**Re: Fuji Clean Minimum Commercial Requirements Approval**

The Suffolk County Department of Health Services (Department), Division of Environmental Quality, Office of Ecology has received and reviewed the design drawings prepared by Fuji Clean USA, dated 9/18/2023 for the "MINIMUM REQUIREMENTS FOR COMMERCIAL APPLICATIONS".

MINIMUM REQUIREMENTS FOR COMMERCIAL APPLICATIONS	
FCU	09.18.23
NOT TO SCALE	AWS L.I.

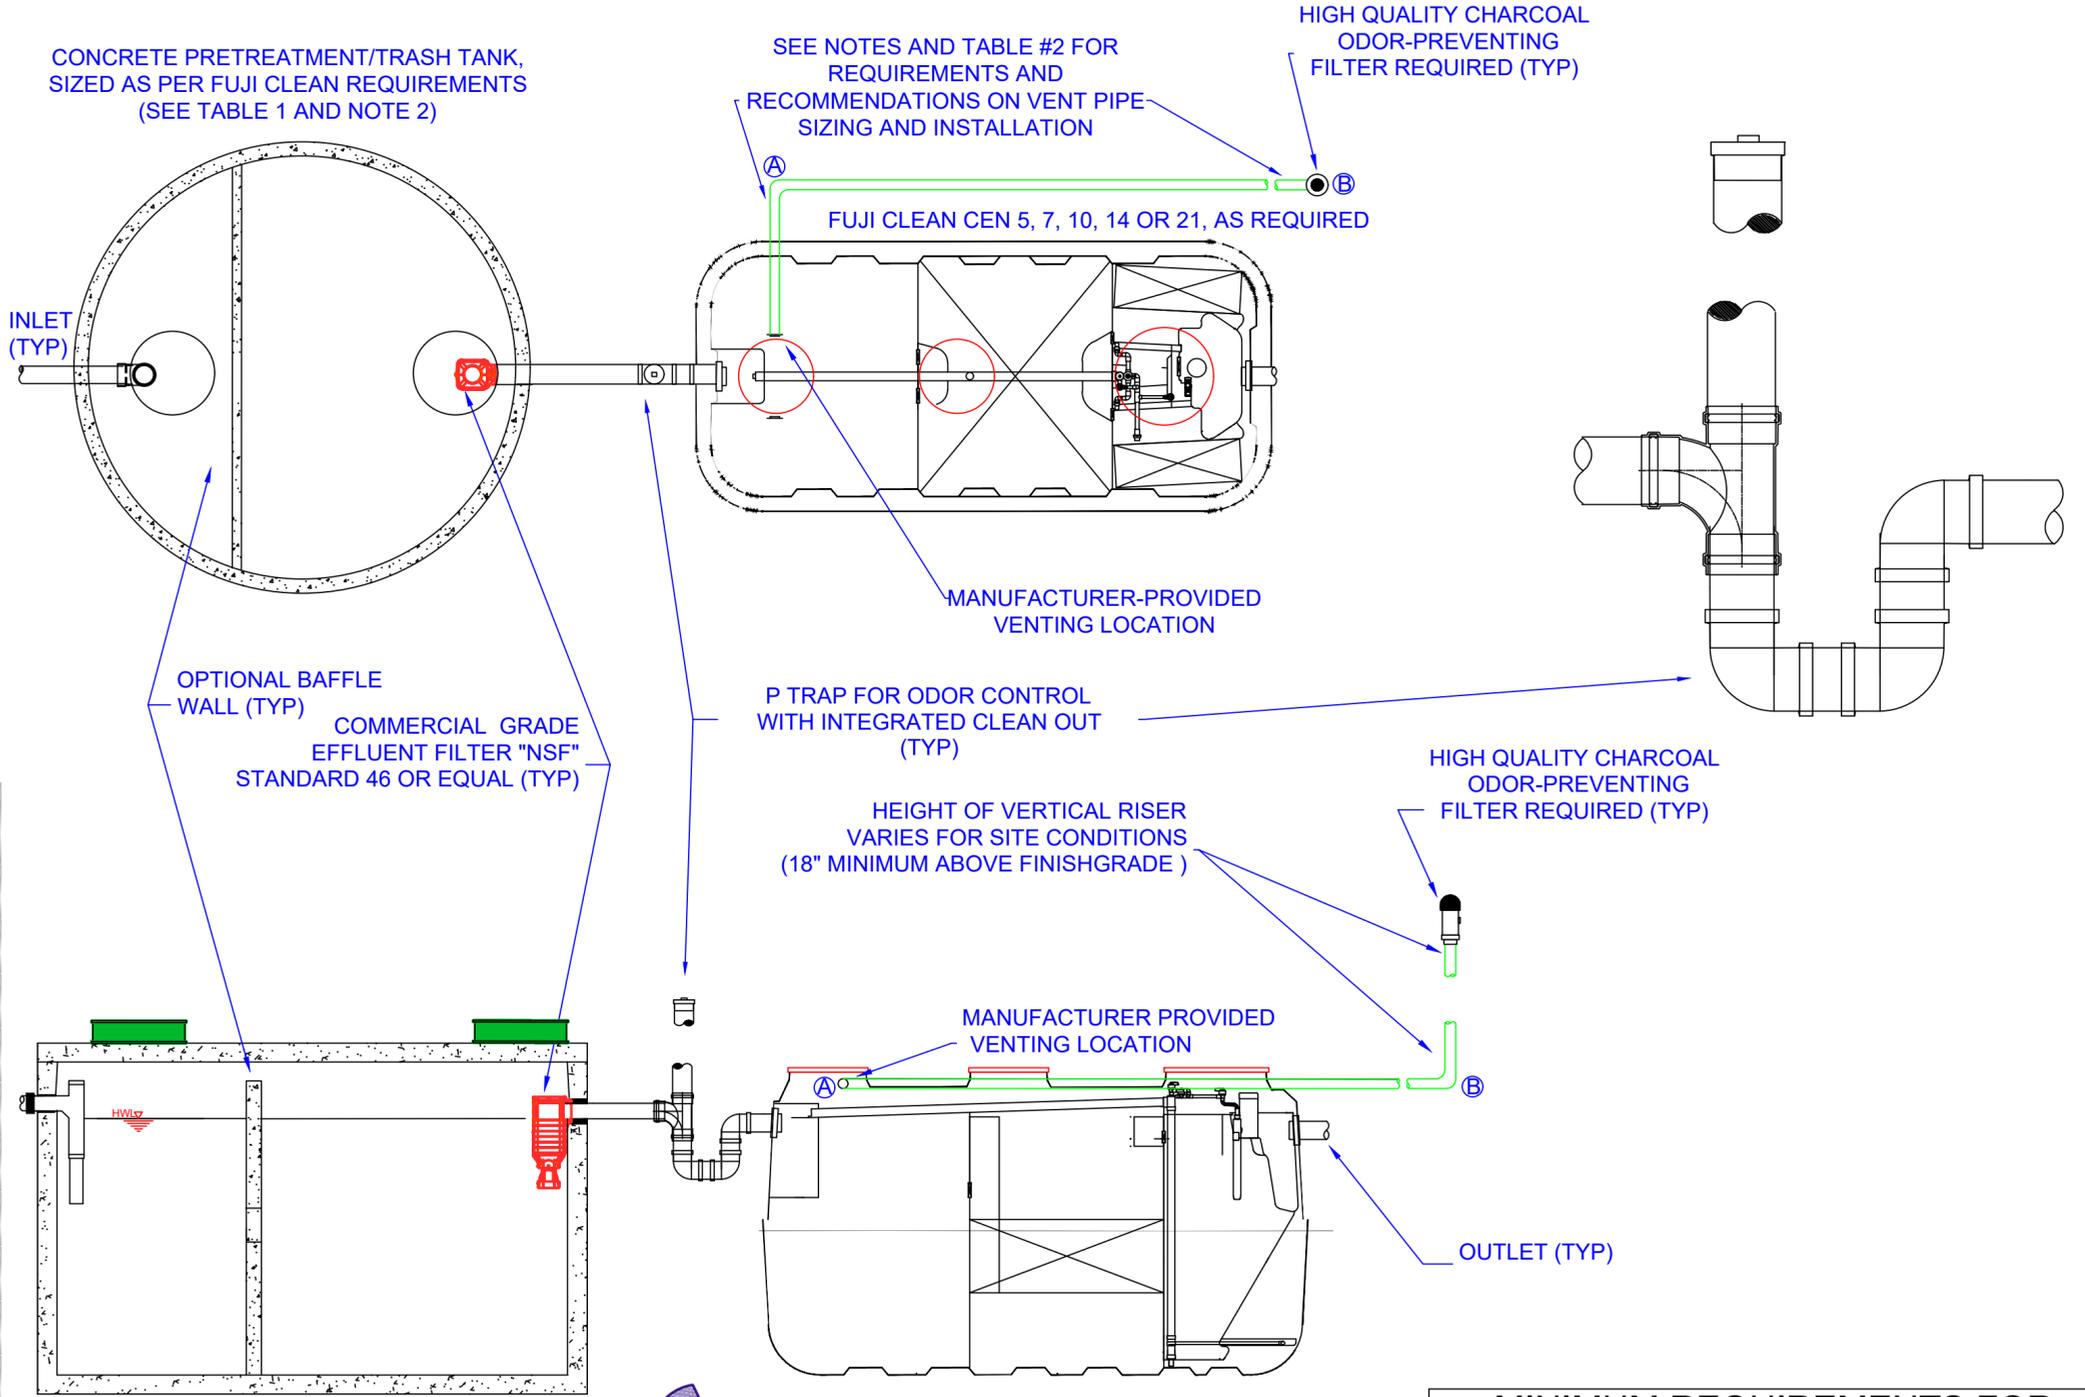
Based on the information provided and in accordance with the "Standards Promulgated Under Article 19 for the Approval and Management of Innovative and Alternative Onsite Wastewater Treatment Systems" §19-103 (H), the Department approves the minimum commercial design requirements for Fuji Clean treatment units, as specified in the approved design drawing.

ACCEPTED BY THE SUFFOLK COUNTY DEPARTMENT OF HEALTH SERVICES  
(DEPARTMENT) BASED ON INFORMATION PROVIDED BY VENDOR.

The Department has reviewed this submittal for completeness and is hereby approved for use in Suffolk County. This approval is solely for the model(s), units(s) and/or structure(s) included in the design drawing(s) and any additional information provided by the technology Vendor. Any changes or modifications to the approved design must be submitted for review and approval by the Department prior to its use in Suffolk County. The Department is not responsible for any errors, omissions, failures, construction defects or installation errors that may occur due to design professional, manufacturer, distributor or installer oversight or negligence.
